Pine Valley Forevergreen - 97 - 1 - 40.06 B LILAC
CENTRAL VAC AND WIRING

PV-07
APRIL 1 2019

The Lilac

SECOND FLOOR | ELEV. A

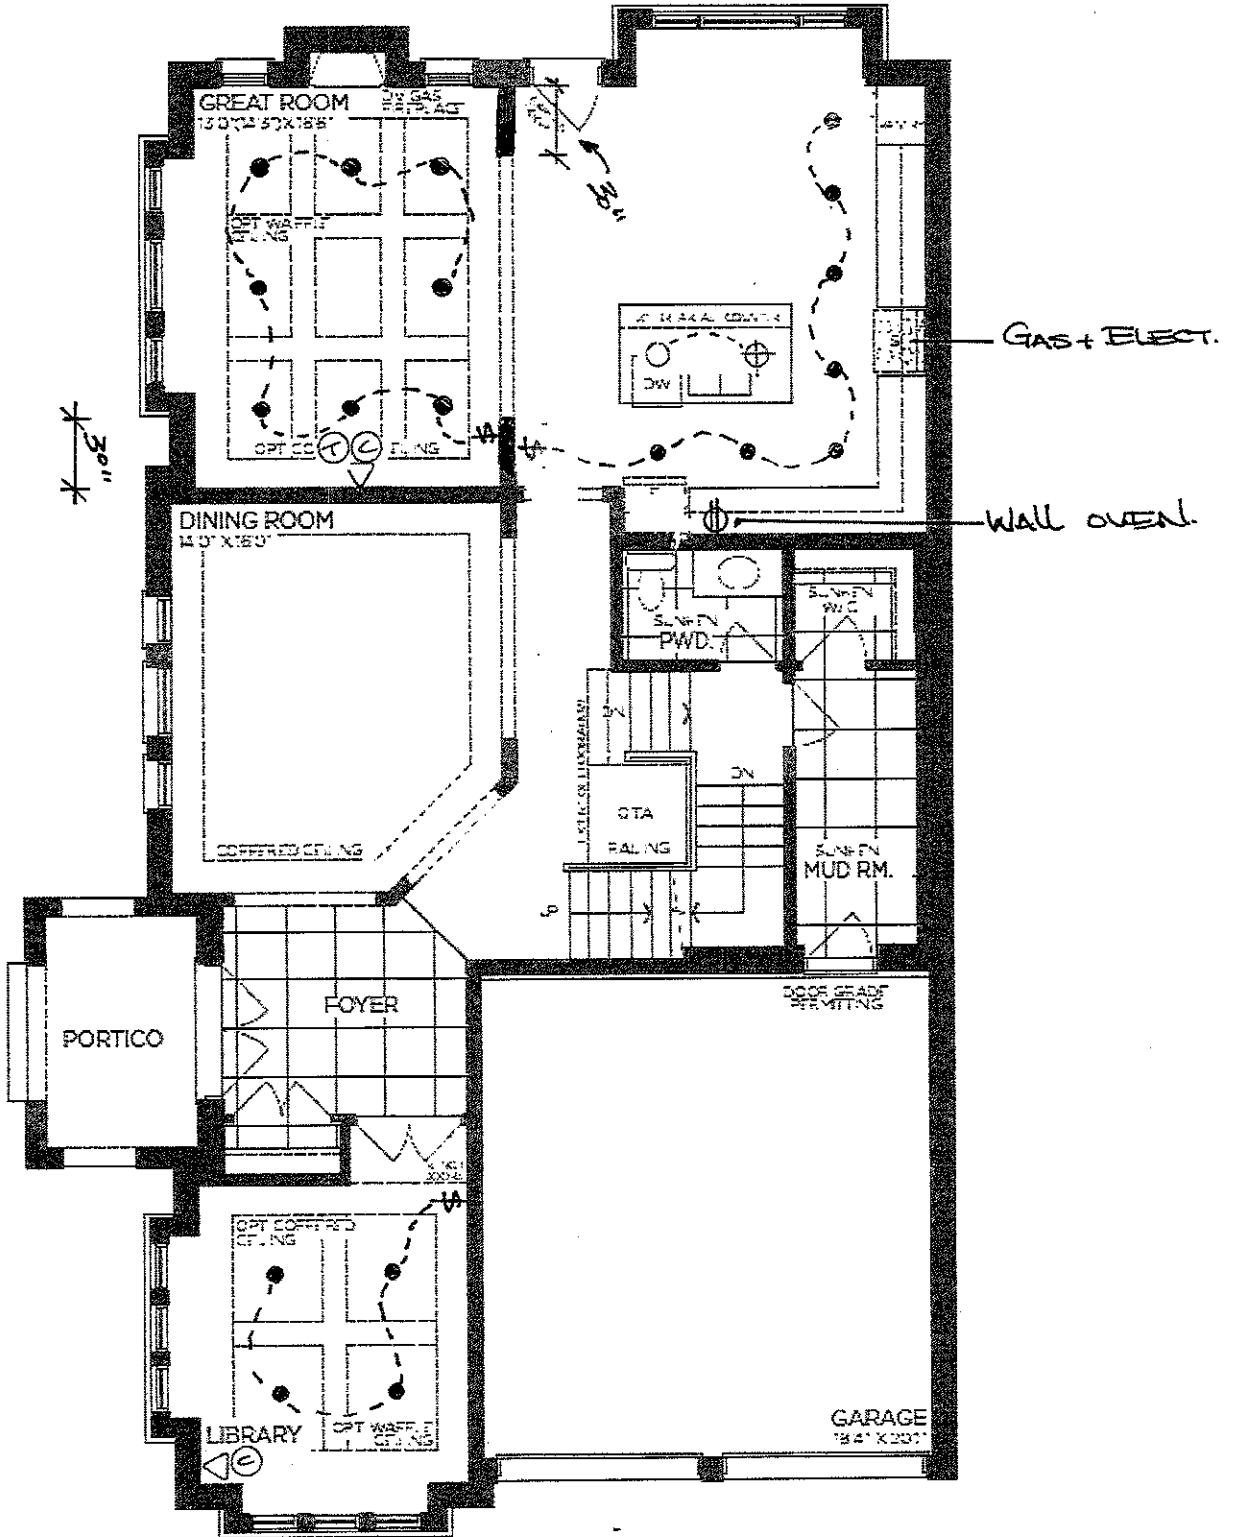
Inv.1,971	1 - 2ND FLOOR: UPGRADE TO SMOOTH CEILINGS - THROUGHOUT SECOND FLOOR
Line27718	Note:
10Mar19 / 16Jul19

Inv.1,971	1 - KITCHEN: ADD FULL ELECTRICAL VALANCE LIGHTING UNDER UPPER CABINETS IN KITCHEN ON A SEPARATE SWITCH - REQUIRES PURCHASE OF VALANCE CABINETRY
Line27709	Note:
10Mar19 / 16Jul19	
Inv.1,971	1 - MASTER ENSUITE: ADD CAPPED CEILING ROUGH-IN FOR FUTURE INTERIOR LIGHT FIXTURE, COMPLETE WITH SEPERATE SWITCH - FIXTURE NOT INCLUDED
Line27711	Note: LOCATE ABOVE TUB
10Mar19 / 16Jul19	
Inv.1,971	4 - MASTER BEDROOM: ADD INTERIOR POT LIGHT - SECOND FLOOR
Line27713	Note: SEE PLAN FOR LOCATION
10Mar19 / 16Jul19	
Inv.1,971	1 - MASTER BEDROOM: ADD A SEPARATE SWITCH - FOR LIGHTING PURPOSES
Line27714	Note: FOR POTLIGHTS
10Mar19 / 16Jul19	
Inv.1,971	1 - ADD FULL ELECTRICAL VALANCE LIGHTING UNDER UPPER CABINETS IN KITCHEN ON A SEPARATE SWITCH - REQUIRES PURCHASE OF VALANCE CABINETRY
Line27830	Note:
10Mar19 / 16Jul19	
Inv.1,971	2 - MASTER ENSUITE: RELOCATE ONLY - STANDARD VANITY SCONCE LIGHT LIGHT
Line27708	Note: RELOCATE STANDARD VANITY LIGHT TO ALLOW FOR 2 LIGHTS ABOVE EACH VANITY (ADDITIONAL ROUGH-IN SCONCES ADDED BELOW)

Inv.1,971	18 - 2ND FLOOR: INCREASE DOOR HEIGHTS TO 96"
Line27833	Note:
10Mar19 / 16Jul19

Inv.1,971	1 - MASTER ENSUITE: UPGRADE FROM FRAMED GLASS SHOWER TO FRAMELESS
Line27715	Note:
10Mar19 / 16Jul19	
Inv.1,971	1 - ENSUITE 2: UPGRADE FROM FRAMED GLASS SHOWER TO FRAMELESS
Line27716	Note:
10Mar19 / 16Jul19	
Inv.1,971	1 - SEMI ENSUITE 3/4: UPGRADE FROM FRAMED GLASS SHOWER TO FRAMELESS
Line27717	Note:
10Mar19 / 16Jul19

Inv.1,971	1 - MASTER BEDROOM DRESSING ROOM: ADD VELUX SUN TUNNEL
Line27832	Note:
10Mar19 / 16Jul19

GROUND FLOOR | ELEV. A

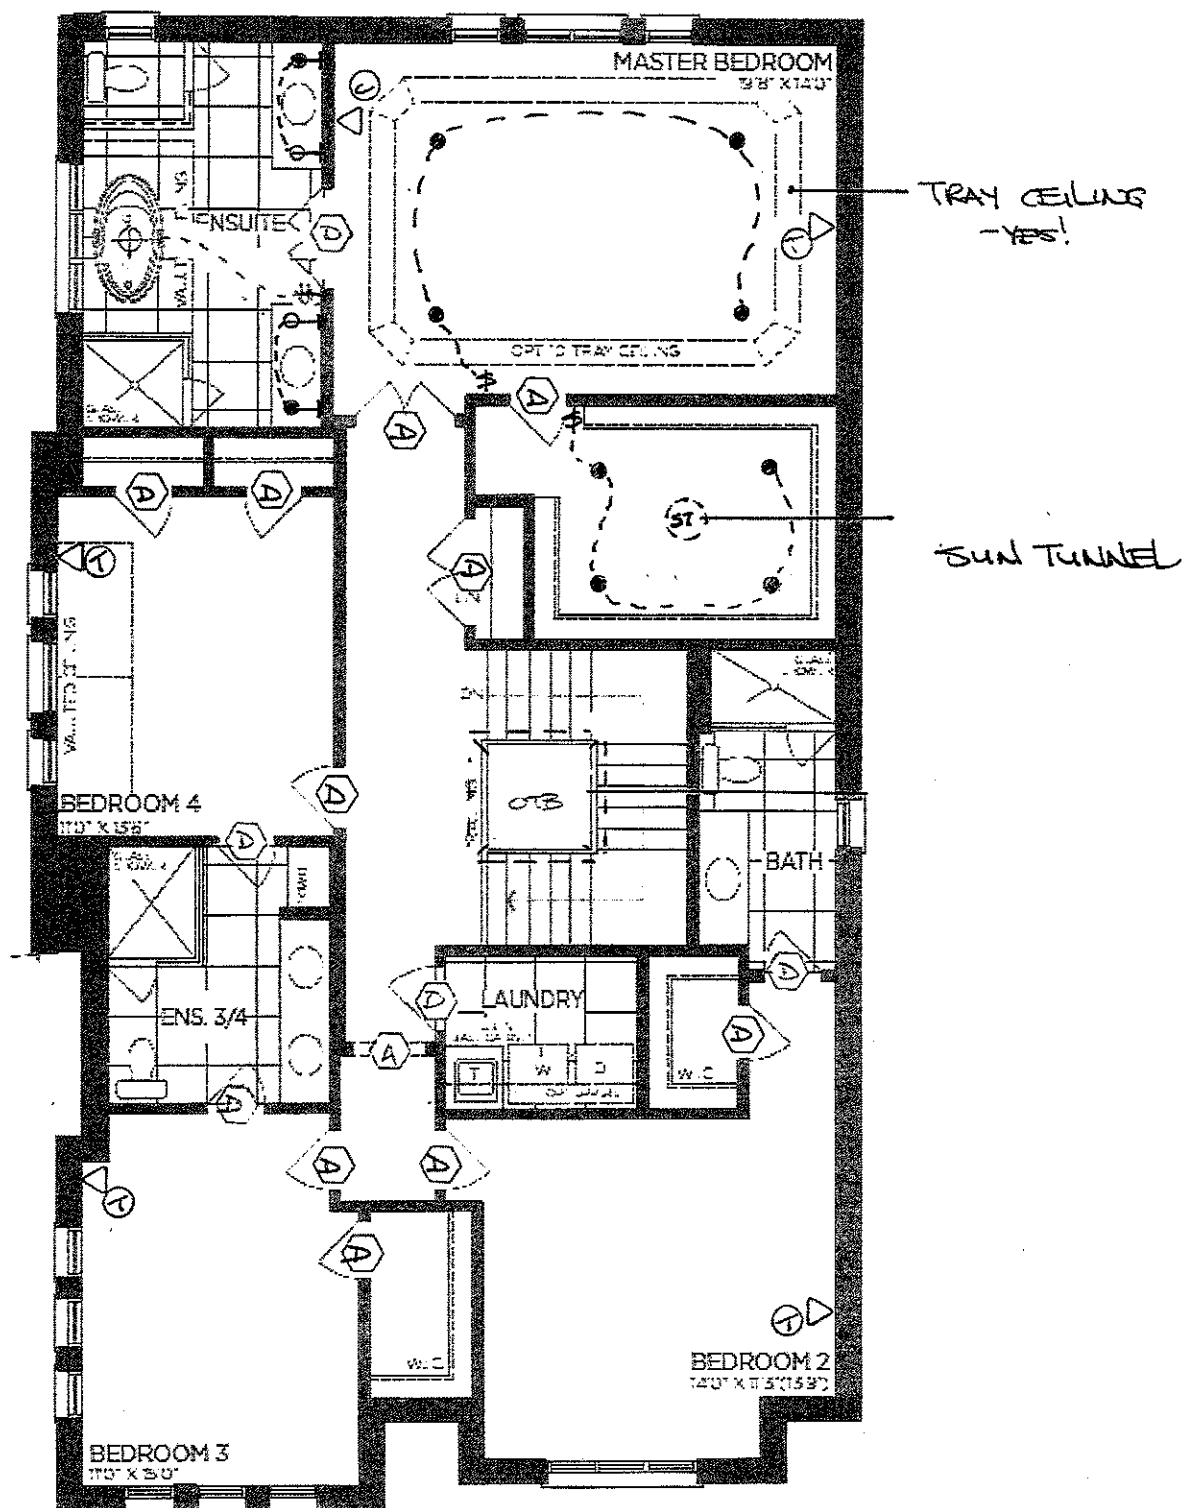
Inv.1,971	1 - GREAT ROOM: UPGRADE TO COFERRED CEILING - GREAT ROOM
Line27679	Note:
10Mar19 / 16Jul19	
Inv.1,971	1 - LIBRARY: UPGRADE TO WAFFLE CEILING - 4 SQUARES
Line27681	Note: CTR-B07
10Mar19 / 16Jul19	
Inv.1,971	1 - LIBRARY: UPGRADE TO COFERRED CEILING
Line27680	Note:
10Mar19 / 16Jul19	
Inv.1,971	1 - GREAT ROOM: UPGRADE TO 9 BOX WAFFLE CEILING
Line27682	Note: CTR-B07
10Mar19 / 16Jul19

Inv.1,971	2 - MASTER ENSUITE: ADD CAPPED WALL SCONCE ROUGH-IN FOR FUTURE INTERIOR WALL SCONCE - FIXTURE NOT INCLUDED
Line27710	Note: LOCATE APPROX. 80" A.F.F. VANITY TO HAVE 2 SCONCE LIGHTS ABOVE EACH - 1 STANDARD + 1 EXTRA
10Mar19 / 16Jul19	
Inv.1,971	4 - LIBRARY: ADD INTERIOR POT LIGHT - GROUND FLOOR
Line27687	Note:
10Mar19 / 16Jul19	
Inv.1,971	1 - KITCHEN: RELOCATE - STANDARD CEILING LIGHT TO ABOVE ISLAND
Line27693	Note: SEE PLAN FOR LOCATION
10Mar19 / 16Jul19	
Inv.1,971	1 - KITCHEN: ADD A SEPARATE SWITCH - FOR LIGHTING PURPOSES
Line27697	Note: FOR POTLIGHTS
10Mar19 / 16Jul19	
Inv.1,971	8 - GREAT ROOM: ADD INTERIOR POT LIGHT - GROUND FLOOR
Line27701	Note: SEE PLAN FOR LOCATION
10Mar19 / 16Jul19	
Inv.1,971	1 - DRESSING ROOM: ADD A SEPARATE SWITCH - FOR LIGHTING PURPOSES
Line27707	Note: FOR POTLIGHTS
10Mar19 / 16Jul19

10Mar19 / 16Jul19	
Inv.1,971	1 - MASTER ENSUITE: ADD A SEPARATE SWITCH - FOR LIGHTING PURPOSES
Line27712	Note: FOR LIGHT ABOVE TUB
10Mar19 / 16Jul19	
Inv.1,971	1 - LIBRARY: ADD A SEPARATE SWITCH - FOR LIGHTING PURPOSES
Line27688	Note: FOR POTLIGHTS
10Mar19 / 16Jul19	
Inv.1,971	7 - KITCHEN: ADD INTERIOR POT LIGHT - GROUND FLOOR
Line27694	Note: SEE PLAN FOR LOCATION
10Mar19 / 16Jul19	
Inv.1,971	1 - KITCHEN: ADD CAPPED CEILING ROUGH-IN FOR FUTURE INTERIOR LIGHT FIXTURE - FIXTURE NOT INCLUDED
Line27696	Note: LOCATE ABOVE ISLAND, USE SAME SWITCH AS STANDARD CEILING LIGHT. SEE PLAN FOR LOCATION
10Mar19 / 16Jul19	
Inv.1,971	1 - KITCHEN: ADD A 240V RECEPTICE ON A SEPARATE SWITCH - FOR FUTURE 'COMBO' WALL OVEN/MICROWAVE - WALL OVEN NOT INCLUDED - DOES NOT INCLUDE BREAKER THAT IS TO BE INSTALLED BY LICENSED ELECTRICIAN AND ARRANGED BY HOMEOWNER AFTER CLOSING
Line27698	Note:
10Mar19 / 16Jul19	
Inv.1,971	1 - GREAT ROOM: ADD A SEPARATE SWITCH - FOR LIGHTING PURPOSES

Line27702	Note: FOR POTLIGHTS
10Mar19 / 16Jul19	
Inv.1,971	4 - DRESSING ROOM: ADD INTERIOR POT LIGHT - SECOND FLOOR (IN ADDITION TO STANDARD CEILING LIGHT
Line27706	Note: SEE PLAN FOR LOCATION
10Mar19 / 16Jul19

Inv.1,964	1 - ADD OPTIONAL TRAY CEILING IN MASTER BEDROOM
Line27515	Note:
9Jan19 / 10Jan19	
Inv.1,971	1 - 2ND FLOOR: UPGRADE TO 96" ARCHWAY
Line27836	Note:
10Mar19 / 16Jul19	
Inv.1,971	1 - GREAT ROOM / KITCHEN: REDUCE WIDTH OF ARCH, LEAVE APPROX. 30" NIB WALLS ON EACH SIDE OF ARCH.
Line27686	Note: SEE PLAN FOR LOCATION
10Mar19 / 16Jul19	
Inv.1,971	1 - FRAMING NOTE: COFFERED CEILING IN GREAT ROOM AND LIBRARY
Line28369	Note:
10Mar19 / 16Jul19

Inv.1,971	1 - KITCHEN: ADD GASLINE FOR FUTURE COOKTOP - COOKTOP NOT INCLUDED - NEW 110V RECEPTICLE REQUIRED & INCLUDED WITH THIS PURCHASE
Line27705	Note:
10Mar19 / 16Jul19

Inv.1,971	1 - KITCHEN: ADD WATERLINE FOR FRIDGE
Line27719	Note:
10Mar19 / 16Jul19

BASEMENT | ELEV. A

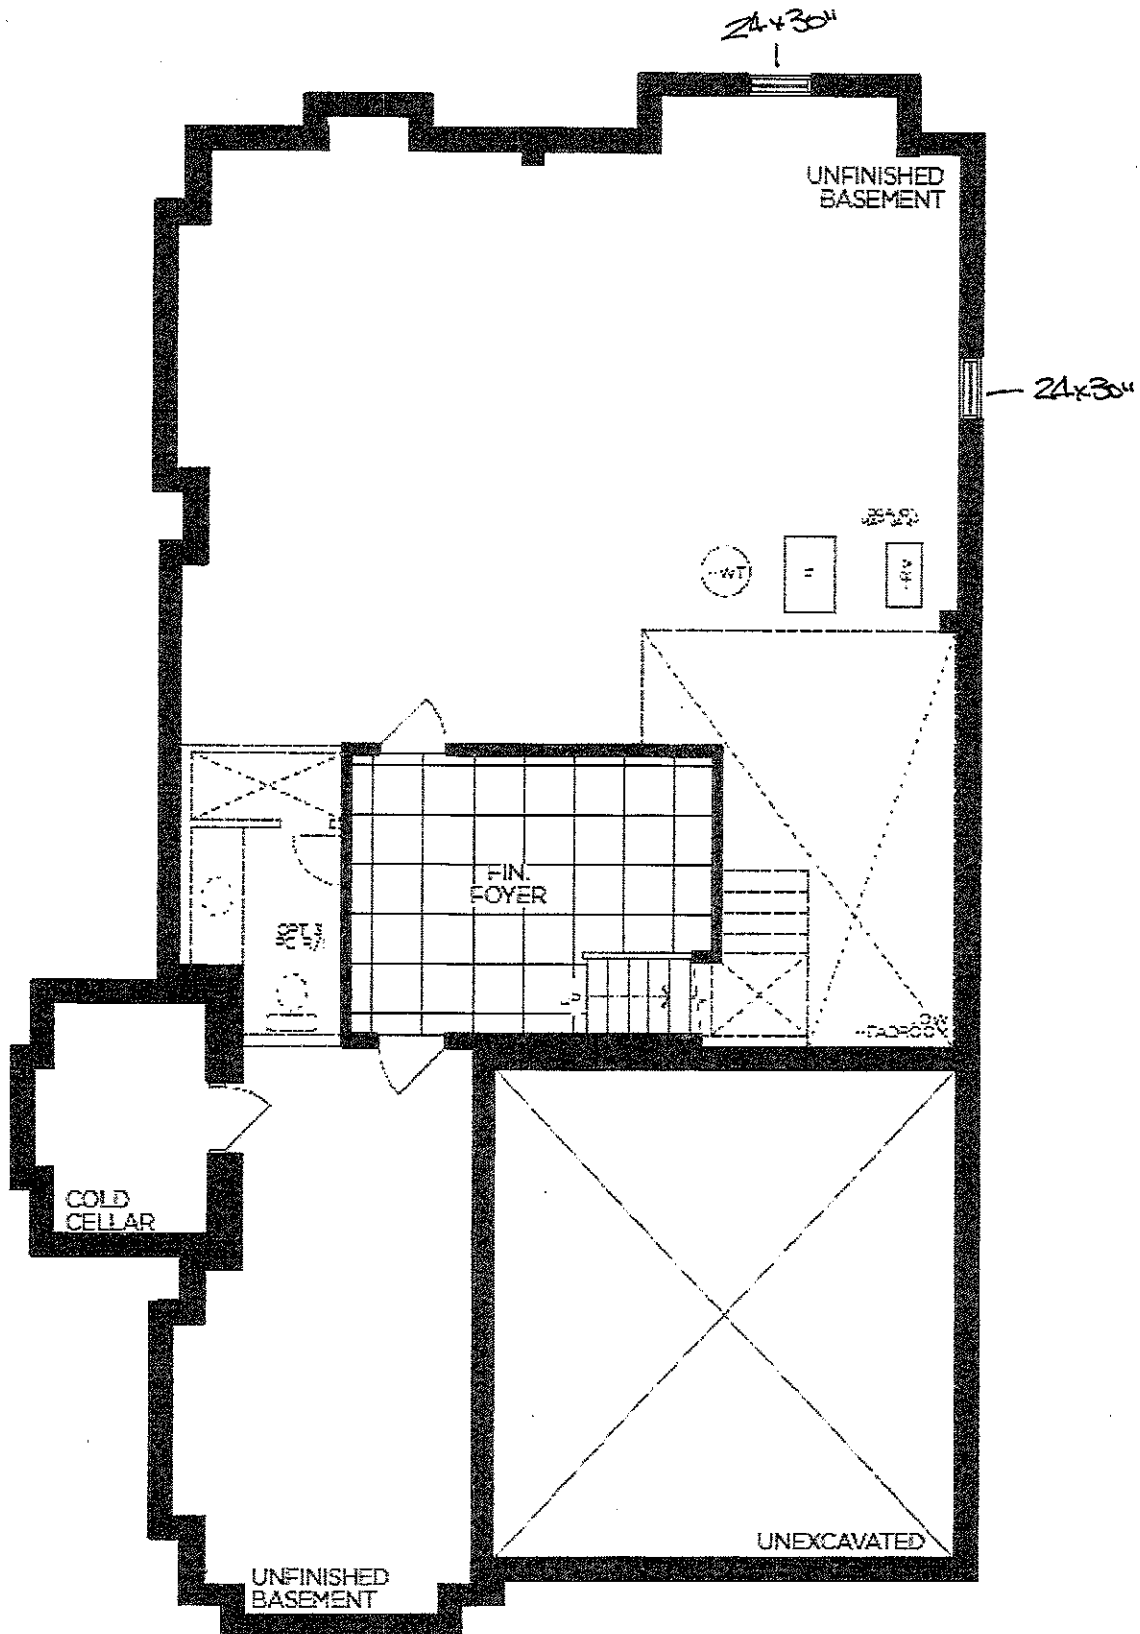
Inv.1,964	2 - UPGRADE EXISTING WINDOW TO 30X24 INCHES
Line27514	Note: Upgrade both existing basement windows, may require window wells.
9Jan19 / 10Jan19
